Comments on the Draft FLAG Phase I Report-REVISED

Weather-Related Visibility Impairment is an Important Factor in Source Impact Assessments

REVIEW OF DRAFT 2008 PHASE I REPORT OF FLAG

Figure 1. Monthly average ammonia concentrations as predicted by CMAQ model simulations.

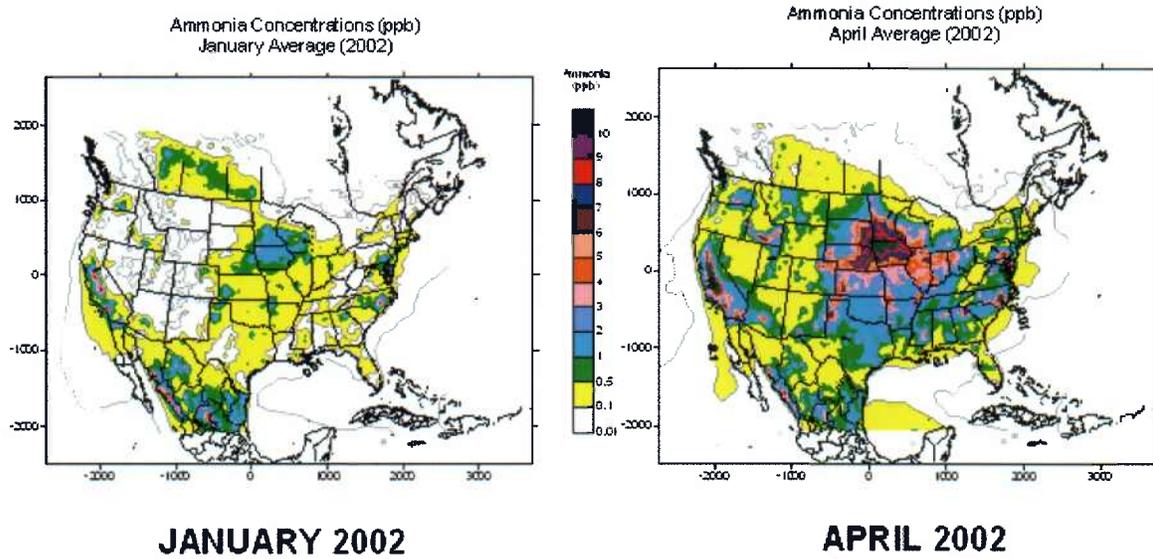
Issue 5. Definition of Model Inputs. The FLAG (2008) report does not define certain model inputs, such as the background ammonia concentration, puff splitting options, etc. The background ammonia concentrations are especially critical because the formation of ammonium nitrate can be limited by the availability of ambient ammonia. Past FLM recommendations involved the use of constant ammonia spatially and temporally. However, data from many sources, including CMAQ modeling simulations, demonstrate the substantial seasonal and spatial variability in ammonia concentrations. See Figure 1 for the monthly average ammonia concentrations over the United States for two months. The variability in time and space is substantial, and this is a significant factor in the proper prediction of concentrations of ammonium nitrate, one of the two most critical species for most visibility applications. Also, Figure 2 shows findings of a model evaluation study conducted in Wyoming, comparing observed nitrate concentrations with predicted nitrate concentrations using both constant background ammonia and application of the Ammonia Limiting Method (ALM), which involves time- and space-varying ammonia. The use of constant background ammonia at the 0.5 ppb and 1.0 ppb levels resulted in overprediction of ammonium nitrate concentrations in the range of factors of 2-

Note that there have been substantial developments in the ability to use CMAQ model output as input into CALPUFF, which will allow the use of varying ammonia in ALM easily, using predefined files for each Class I area. In addition, this method allows for better background data to be included, reflecting for example future emission reduction scenarios as defined in the CMAQ simulations.

Figure 2. Comparison of observed and predicted NO₃ concentrations at the Bridger IMPROVE monitoring site using ALM (blue) vs constant ammonia of 0.5 ppb (pink) and 1.0 ppb (green).

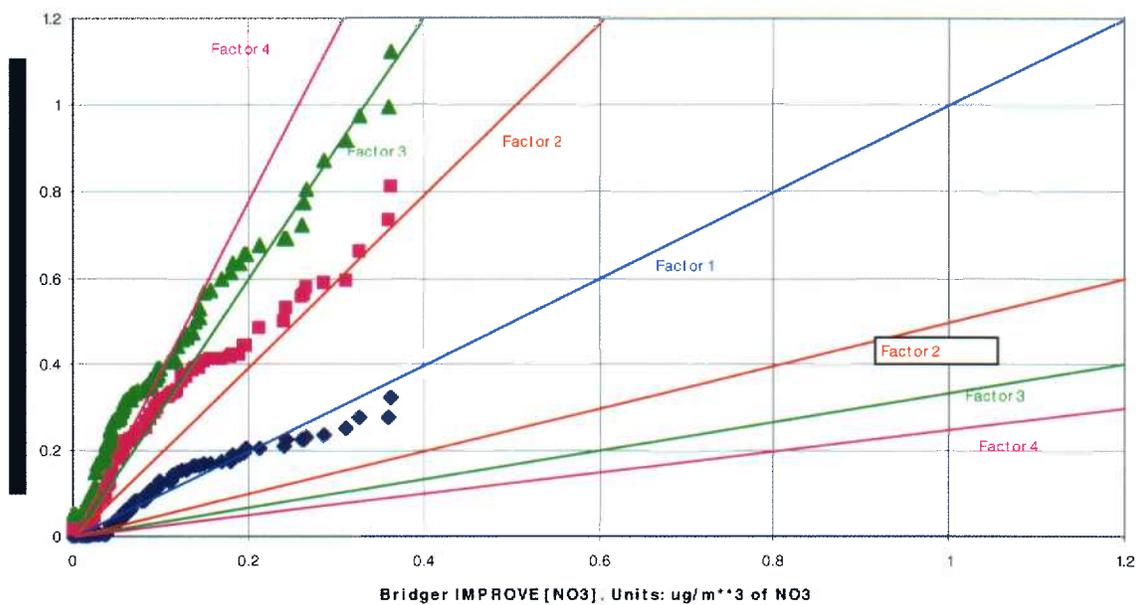
3 and 3-4, respectively. The use of ALM resulted in much closer agreement with the observations.
